B707-A-000186

SUMMARY OF B707 RCRA RESPONSE TO (10/26/05) COMMENTS TO CDPHE

Figure 6A
Remaining UG
Utilities/Structures
for Building 707 Cluster

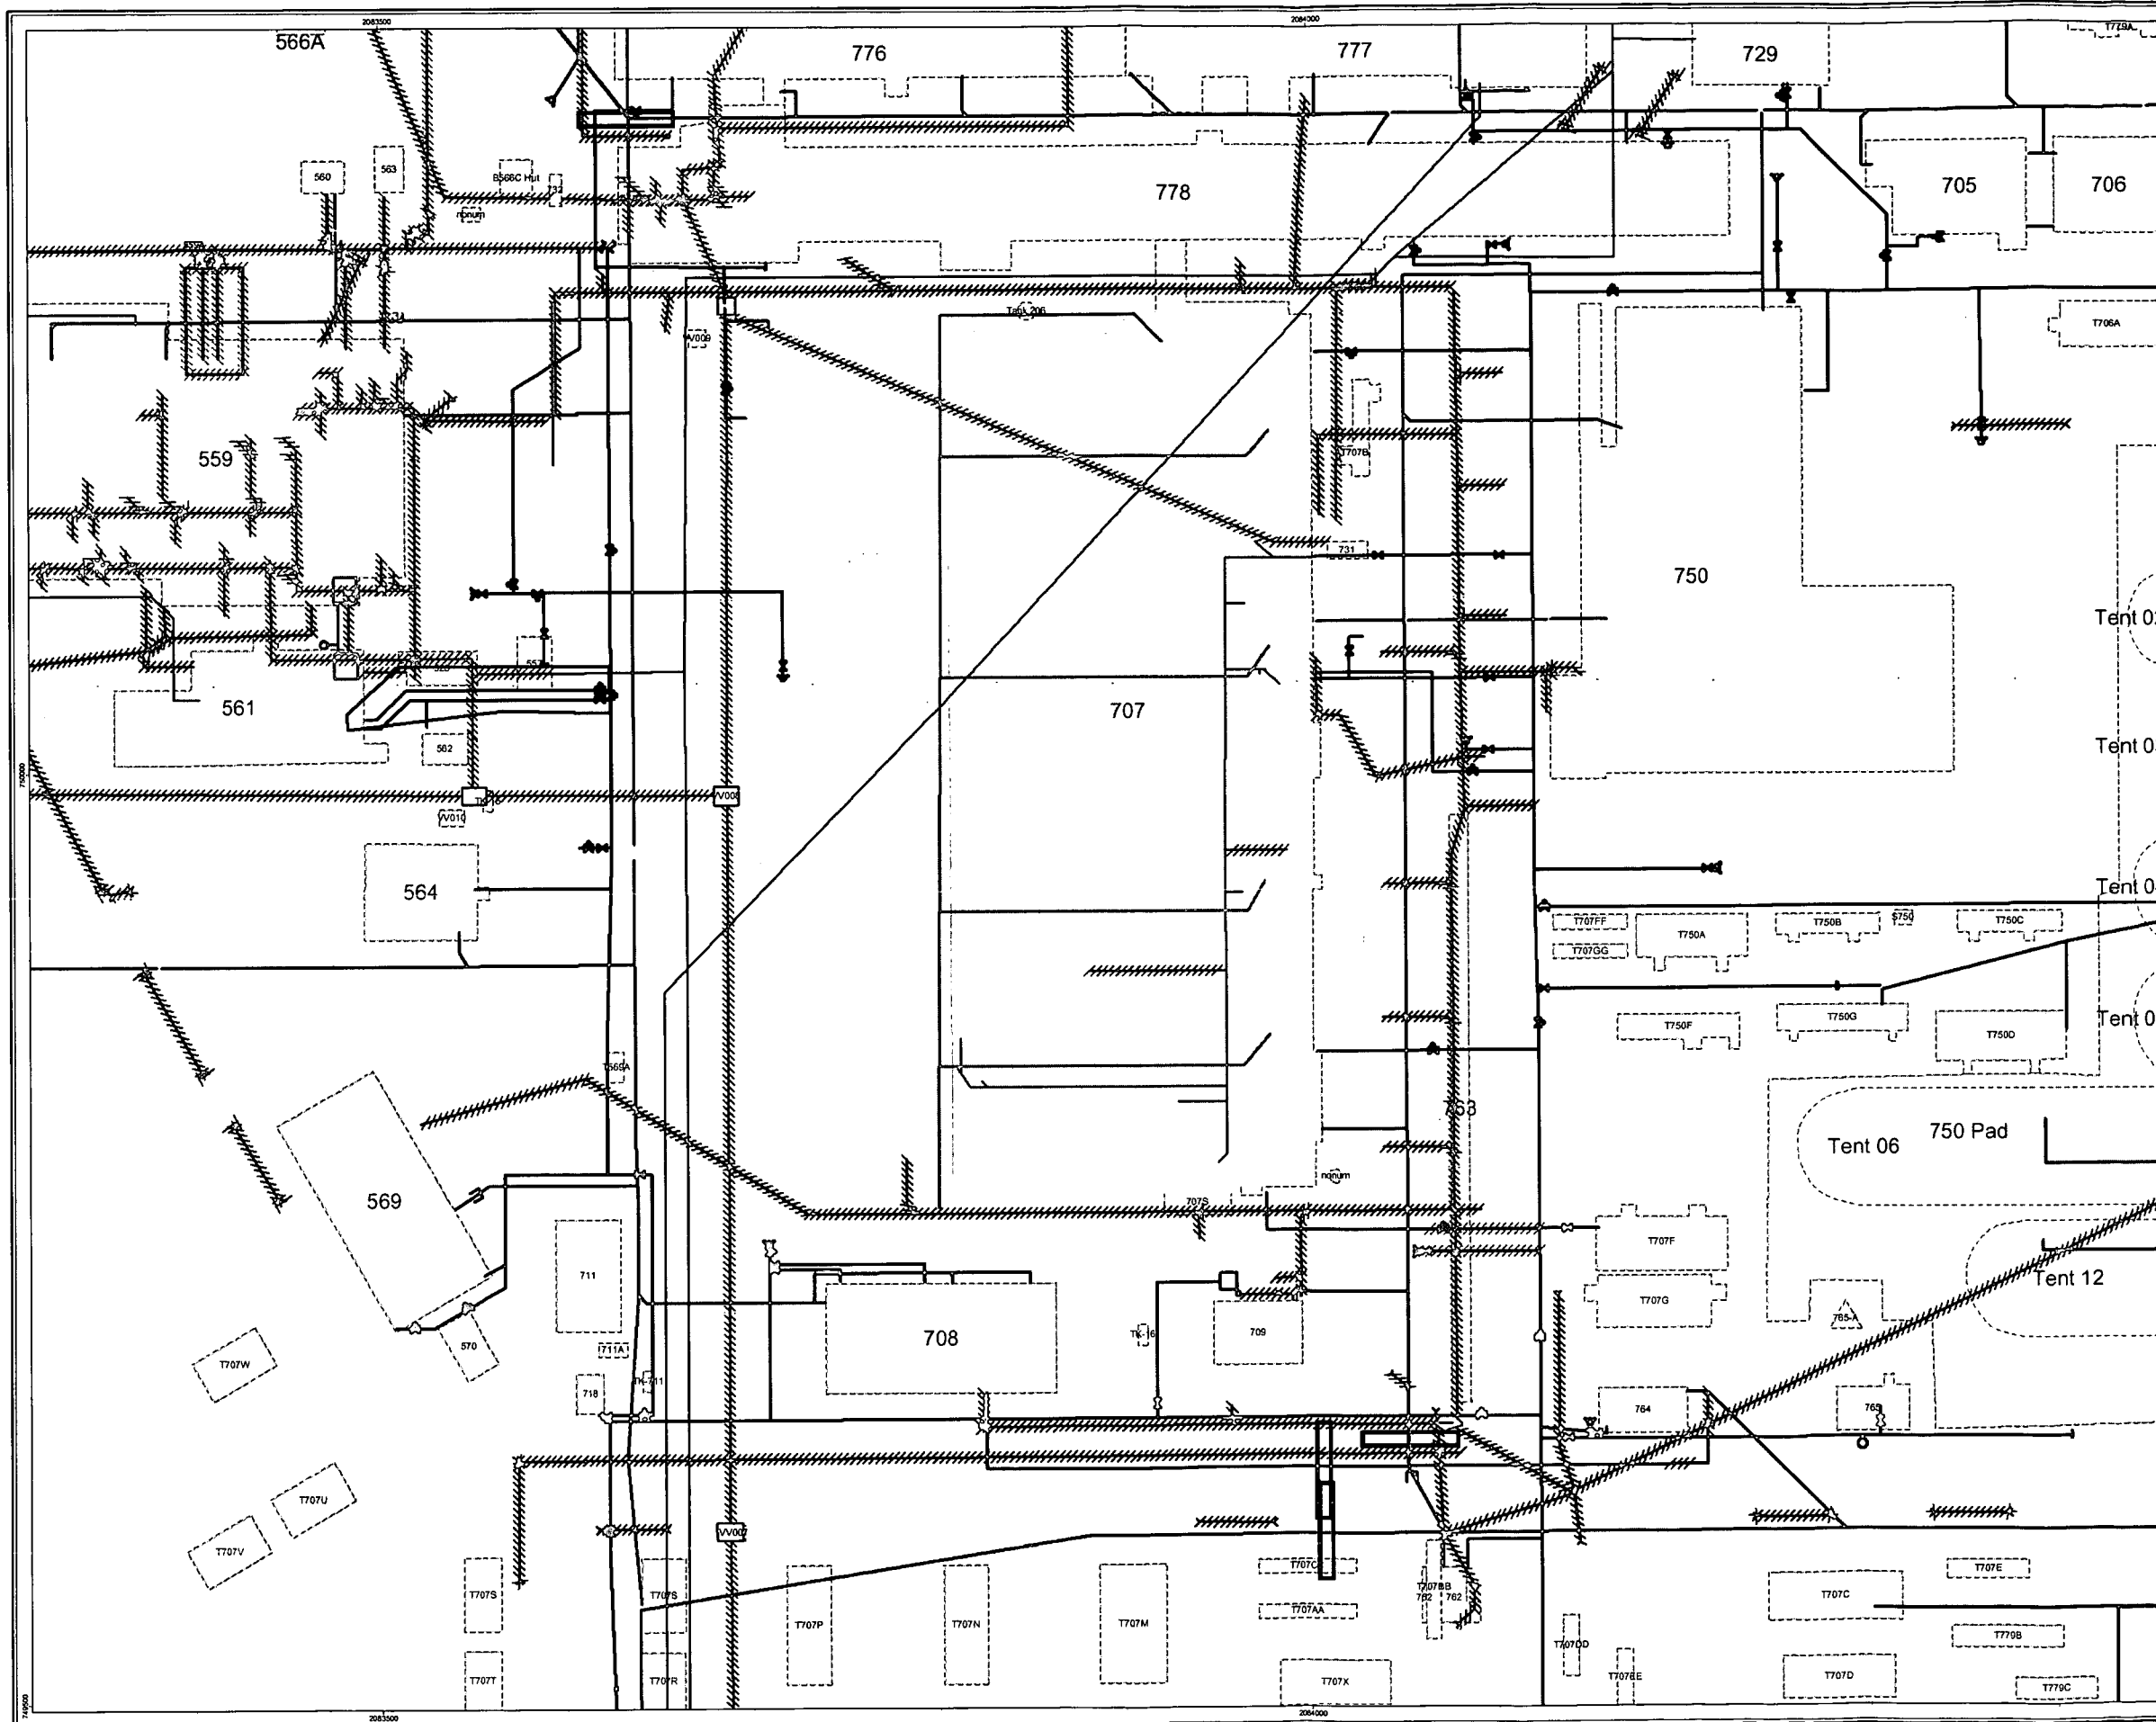
- 2) Figure 6 does not provide a clear indication of the removed and remaining lines or sections of lines, especially associated with structures other than B707 and 778, such as 708, 709, 711, 732, 731, etc. Since D&D completed all actions associated with this cluster, please provide the appropriate information as to the final condition of this area.

RESPONSE:

An updated drawing (Figure 6a) is provided which should be used in conjunction with Figures 5 & 6. The text in the ER closeout report for IHSS 700-3 indicates that some uncontaminated portions of the B778 slab remain. However, based on personal interviews and drawings submitted to GIS, none of the slab or foundation remain at B778.

FIGURE 7a

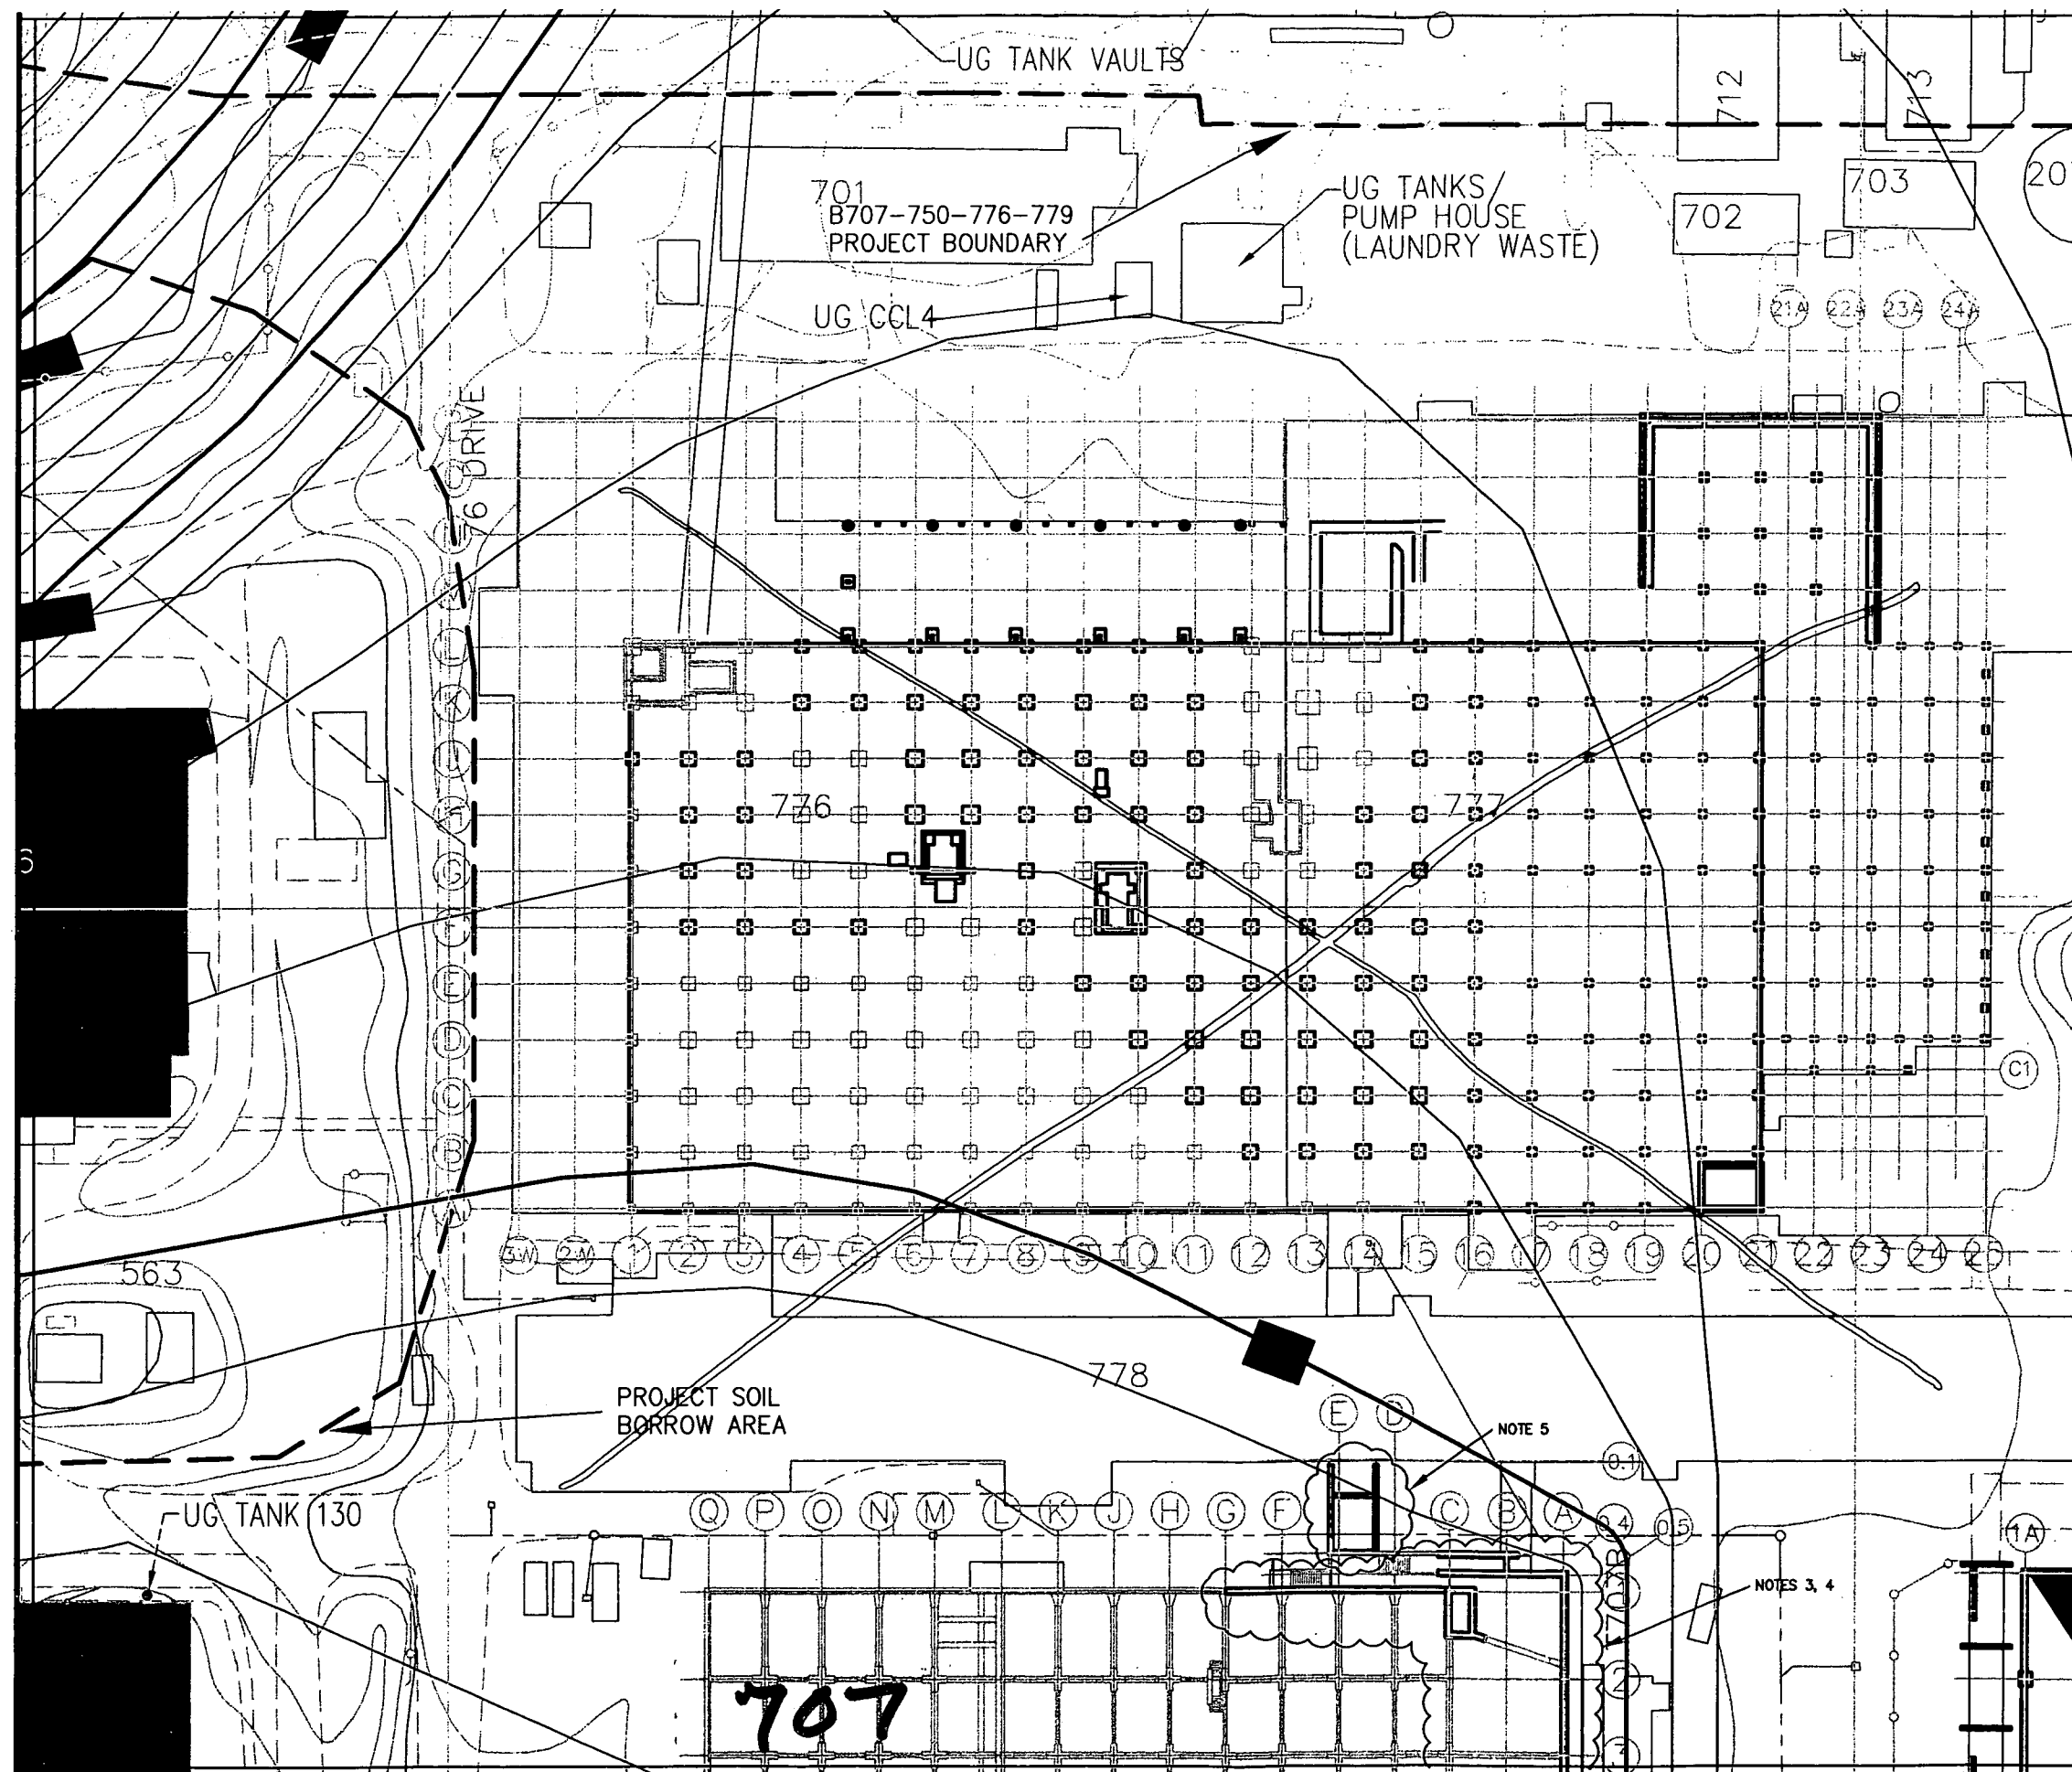
- 1) The figures provided do not provide the information requested. Figure 7 does not show all of B707, nor all of the facilities included in this report. Figure 7 does not show or identify the specific structures removed or remaining, or the information provided in the notes provided on the figure (where are "column lines 0.4, 0.5, and 1"). As such, please provide an appropriate figure as previously requested.

RESPONSE:

Figure 7 and 7a (cut sheets) are meant to only show the parts of B707 foundations that were removed. This detail was available only due to the land configuration aspects and is not part of the Site Engineering documents. The attached Figure 6a is provided to show the cluster in total and what was left and what was removed.
